**Request for Additional Information No. 505 (5902,5735,5869,5754,5803,5950,5744),
Supplement 6**

U. S. EPR Standard Design Certification

Docket No. 52-020

Application Section: FSAR Chapter 7

Figure 4-2—Block Diagram with Diversity Attributes

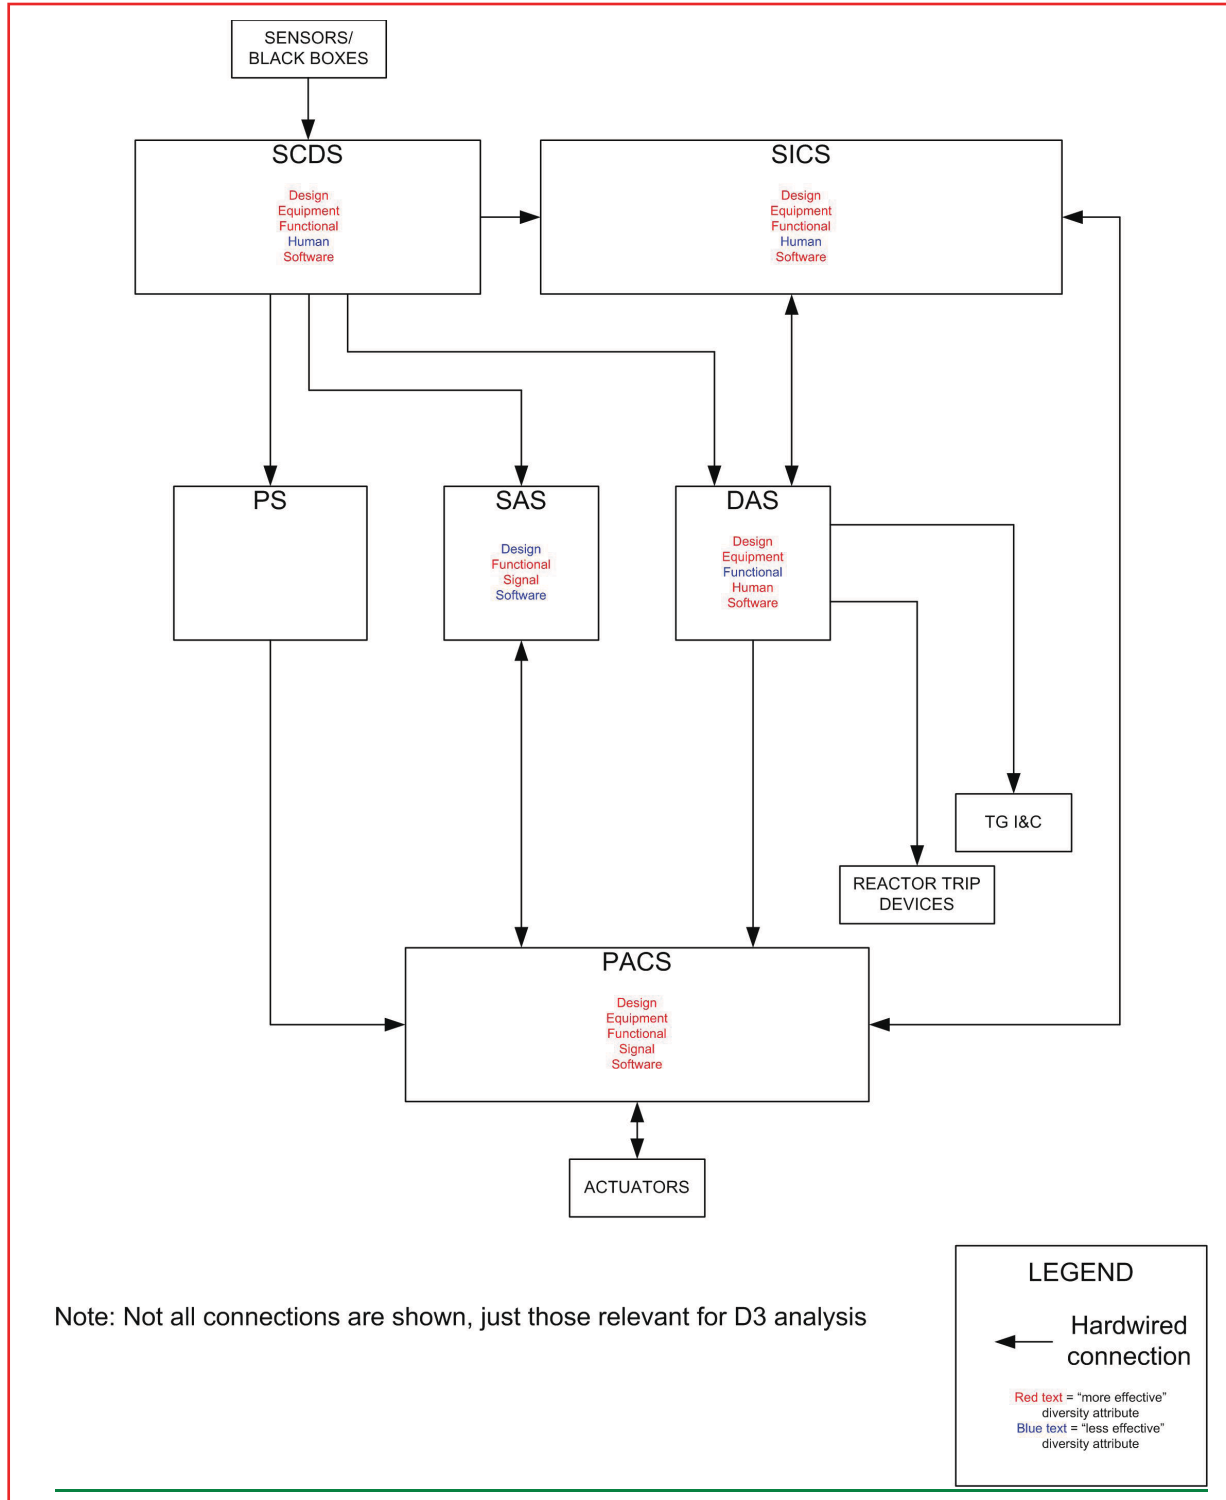
- a. Section 3.2.1 of Technical Report ANP-10304 provides a diversity design commitment between the PS TXS platform and the DAS platform that the design organization, management, designers, programmers, and testing engineers will be different. However, Section 4.2 of the same report states that it is likely that different design organizations will be responsible for the design of the two systems and that this will not be determined until the detailed design of these systems is in progress. These two design statements for the DAS and PS credited human diversity are conflicting. The applicant is requested to clarify the commitment for human diversity.

- b. Table 2-1 of Technical Report ANP-10304 states that the SICS indicators can include programmable electronic I&C technology, which, according to Tier 2, Section 7.1, Interim Revision 3 mark-ups, can be TXS microprocessor-based. By contrast, Section 4.2 of Technical Report ANP-10304, SICS design diversity, states that the indications provided in SICS are performed by hardwired, analog components. The information provided for the design basis items, taken alone and in combination, should have one and only one interpretation. The staff request the applicant to provide clear design descriptions about the type of SICS indicators that are credited in the Technical Report ANP-10304.

- a) Technical Report ANP-10304 will be revised to clarify the commitment that different design organizations will be responsible for the design of the two systems.
- b) Section 4.2 in Technical Report ANP-10304 will be revised as shown in the attached markups.
- c) U.S. EPR FSAR Tier 2, Section 7.1 defines programmable electronic instrumentation and control (I&C) technology as: "I&C technology that is based on solid state components whose function is programmed via software." While this can include microprocessors, the safety information and control system (SICS) indicators credited in the defense-in-depth analysis do not use Teleperm XS (TXS) microprocessor-based programmable electronics.
- d) Section 4.2 in Technical Report ANP-10304 will be revised as shown in the attached markups.
